BEFORE THE FAST-TRACK EXPERT CONSENTING PANEL

of the application for approvals by Pukerua Property Group Limited Partnership for
the Mt Welcome Project, Pukerua Bay, Porirua (FTAA-2603-1181)

STATEMENT OF EVIDENCE OF DARCY BRITTLIFF

(Stormwater, wastewater, earthworks management and water supply infrastructure)

Figure 6: Roof runoff without infiltration

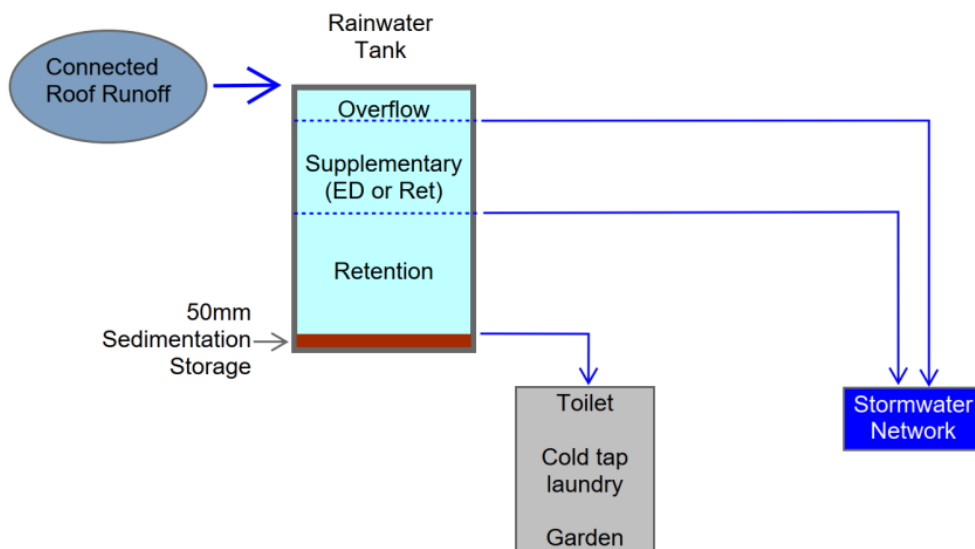
26. Issue 1 identified that the most likely sediment source was the piped outlets from the development into the flow paths on the site. Caucus agreed that onlot tanks provide hydrological control.
27. I provide Figure 6 below sourced from the GWRC Hydrological design guideline that illustrates this concept which is applicable to this site:

28. The concept is roof runoff is collected and retained for use on the property. An overflow is set mid-tank with a small diameter outlet. This allows a portion of rainfall to be slowly released over the following 24 hour period – this is extended detention which is intended to mitigate increases in runoff rates for small frequent rainfall events due to the introduction of development/new roofs in a catchment.
29. In terms of water reuse it was agreed roof water tanks provide water conservation benefits and resilience.
